September 2, 2020

TO: Warrenton Planning Commission
FROM: Mark Barnes, Interim City Planner
RE: Site Design Review Application, SDR 20-05 and VAR 20-04, NW Natural Gas

GRADING/DRAINAGE PLAN/SE DOLPHIN AVENUE

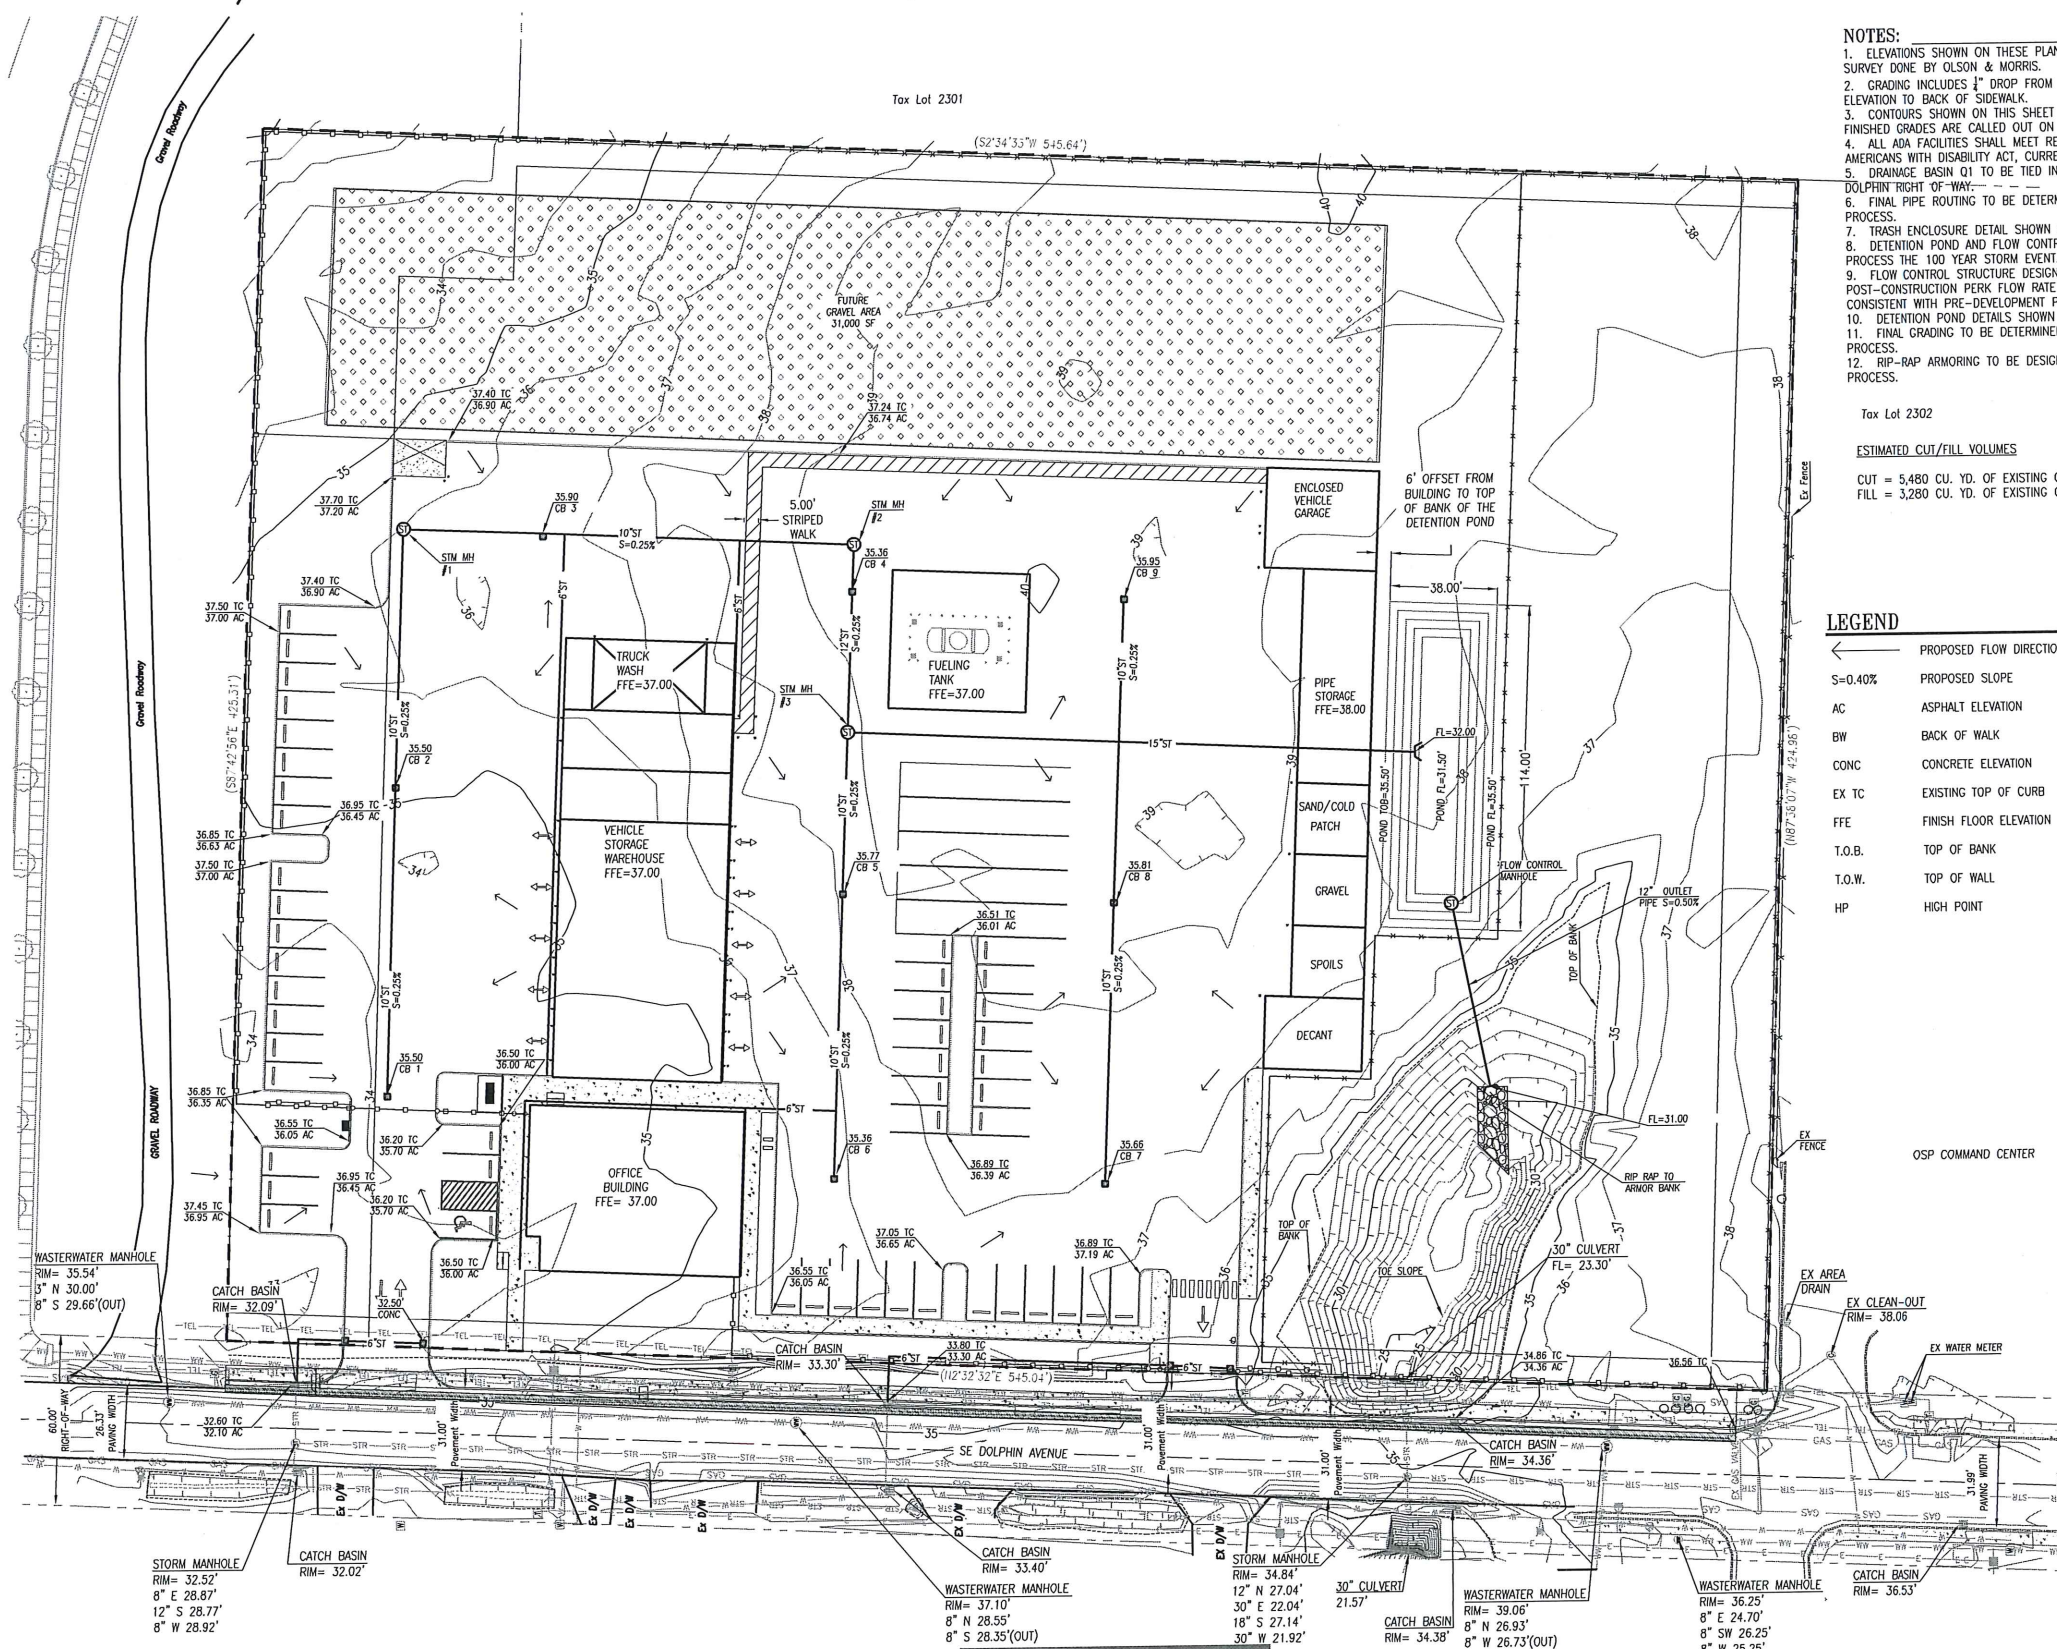
- 17 Sheet C2.0, update excavation and fill quantities,
- 18 Sheet C4.0, update driveway width dimensions.
- 19 The revised stormwater report calculations now include an exfiltration component in the detention basin. The body of the report does not mention exfiltration. Provide references to support the inclusion of exfiltration.

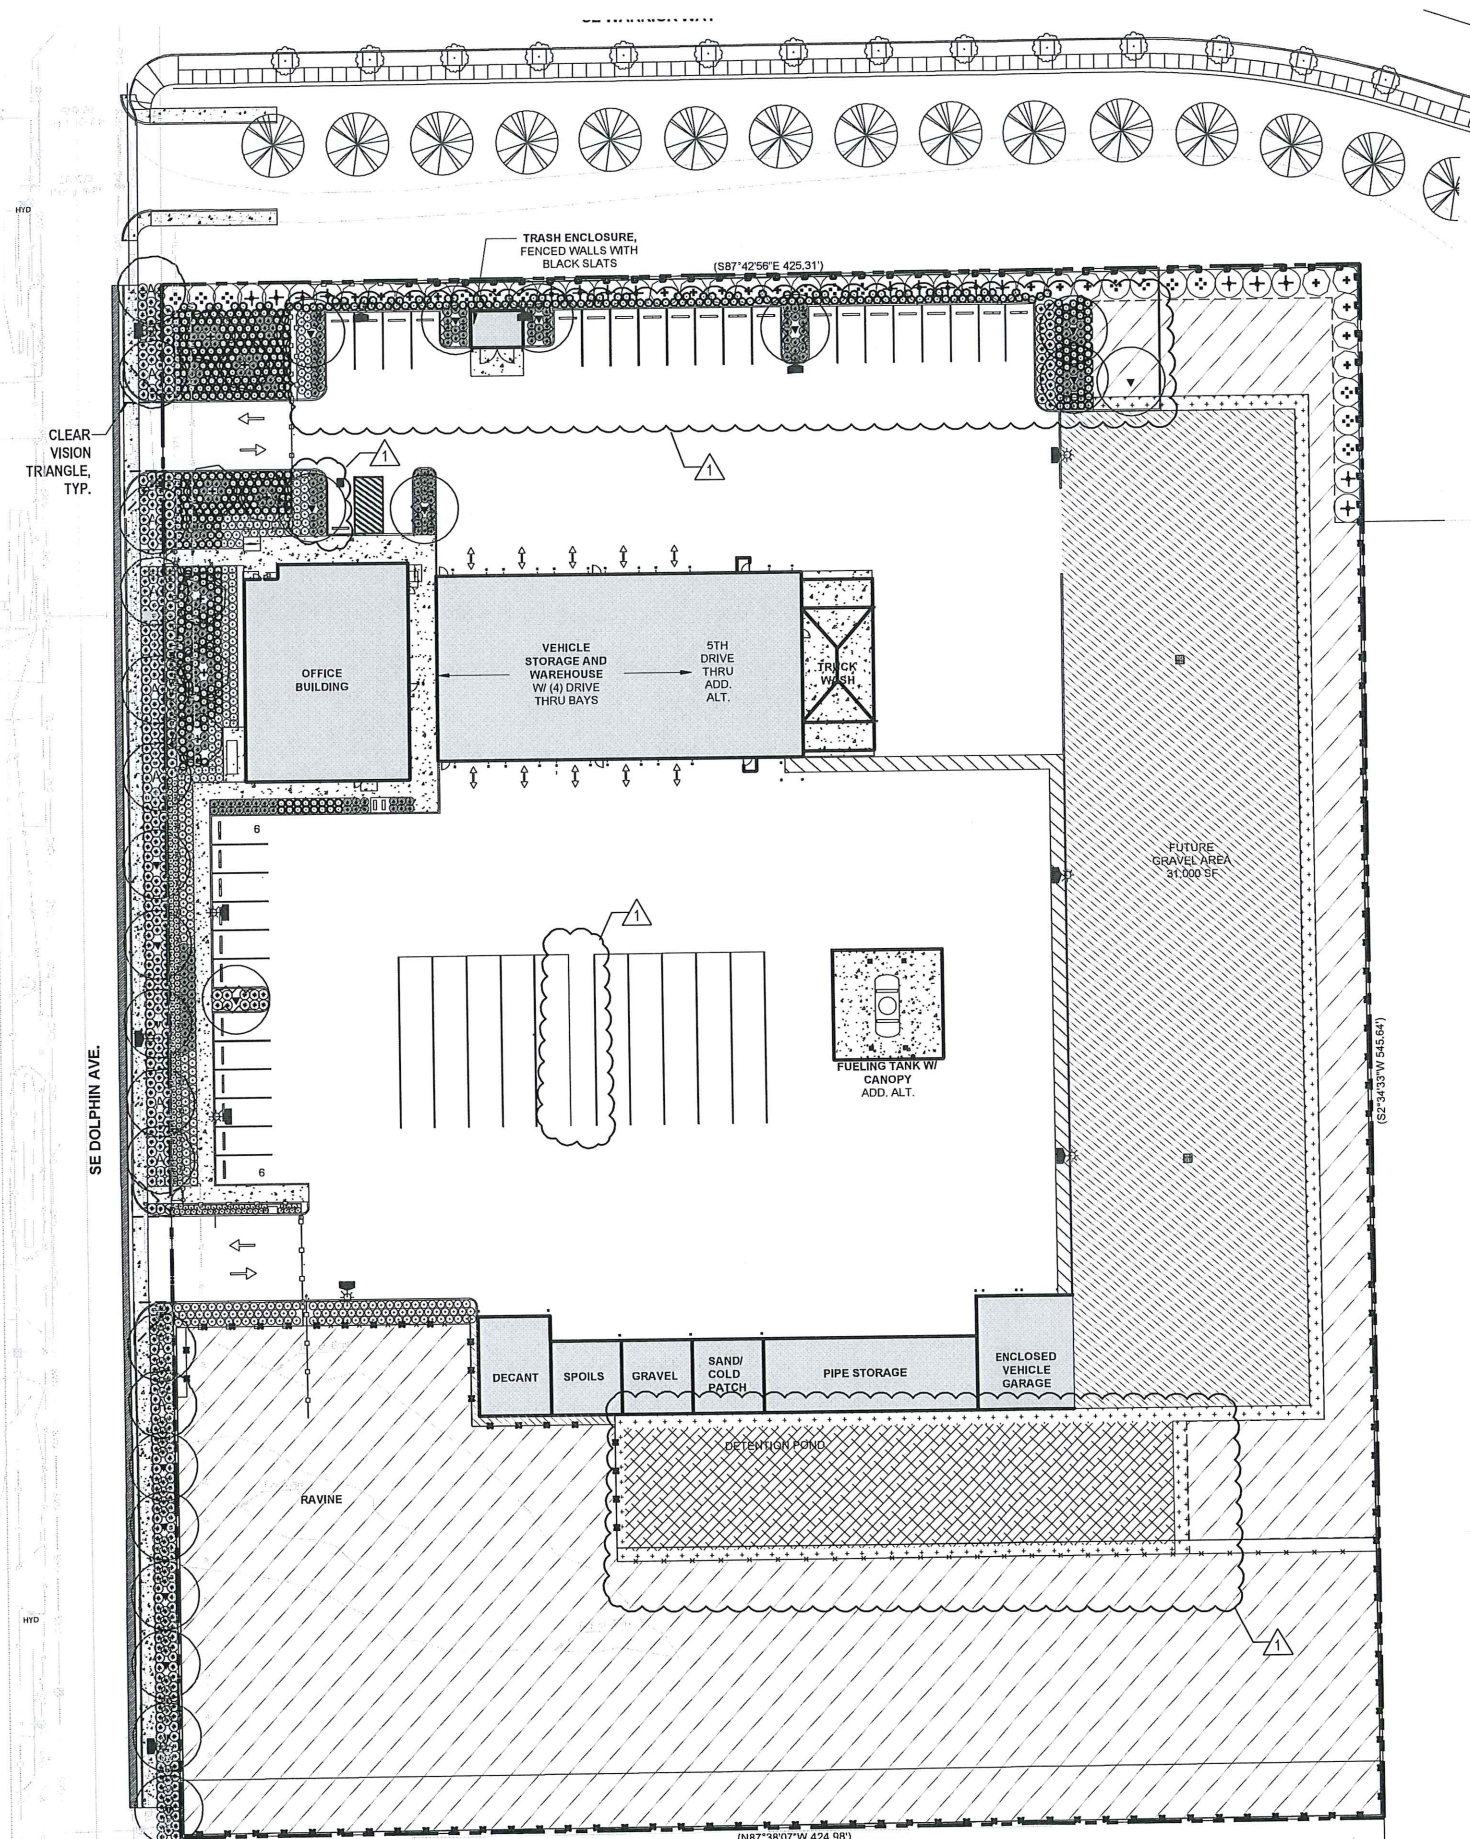
The proposal includes a landscape plan on sheet L2.

The proposed landscape plan shows that interior landscaping will cover 110,625 square feet of the 231,847 square foot site, or about 48 percent of the site. These figures include 70,331 square feet of undeveloped open space on the site.

A1

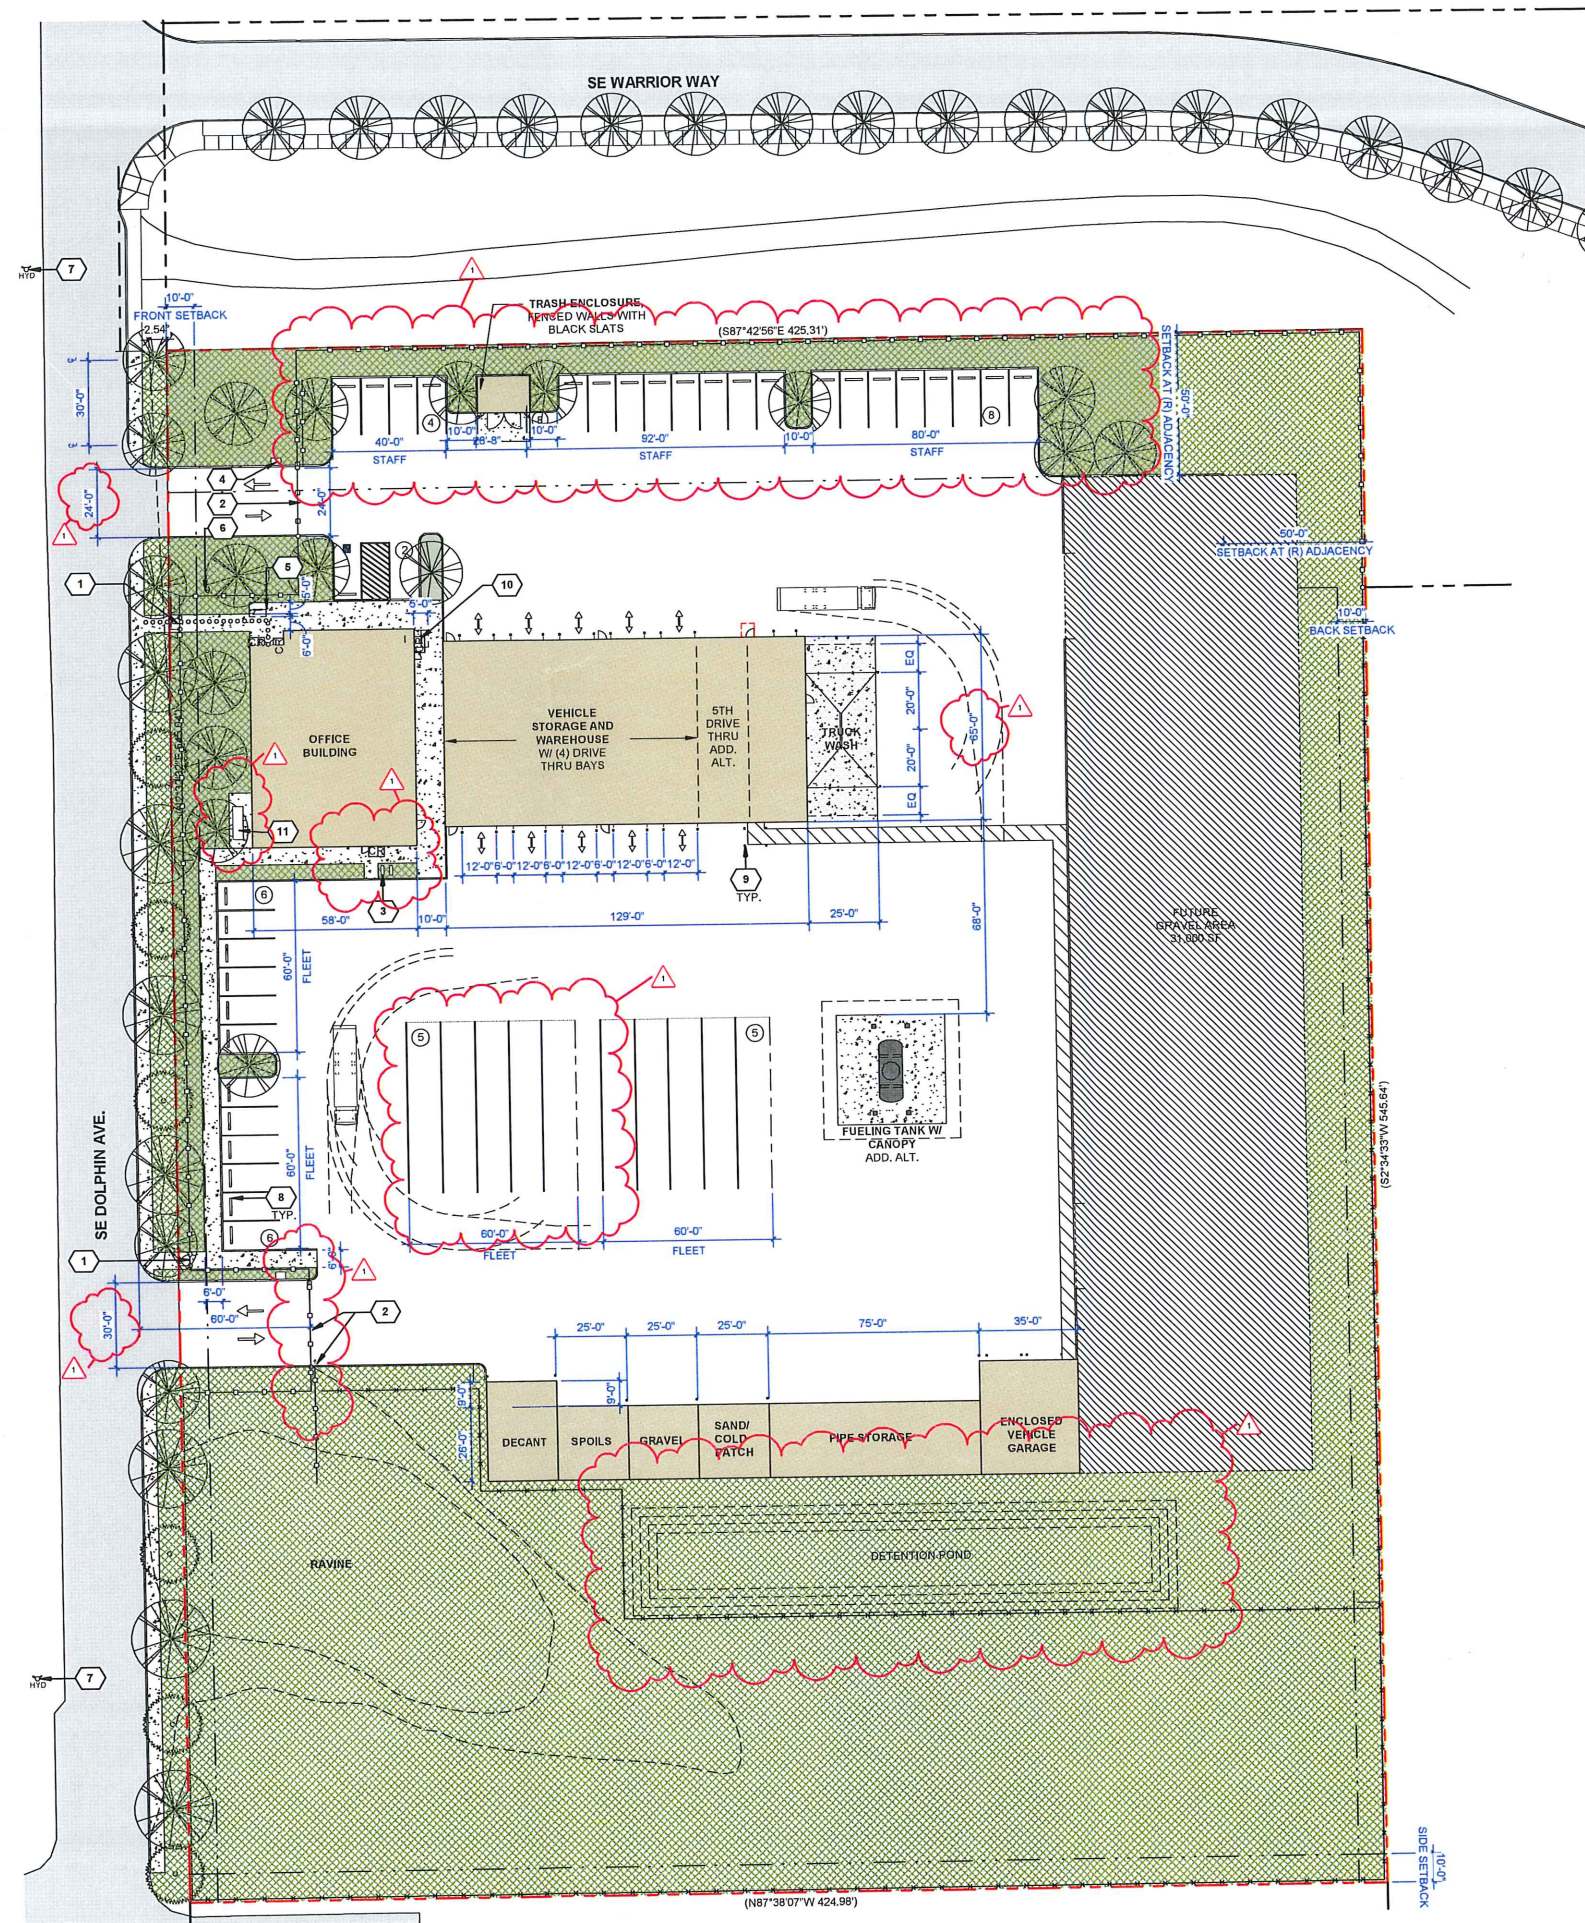
Please see attached for revised sheets only to the LUR drawing set. This includes parking landscape revisions to the site including a revision to the detention pond incorporating the compacted gravel area, see updated civil and landscape plans. Also included are other misc. revisions to the site plan, see Sheet A1 showing changes clouded.
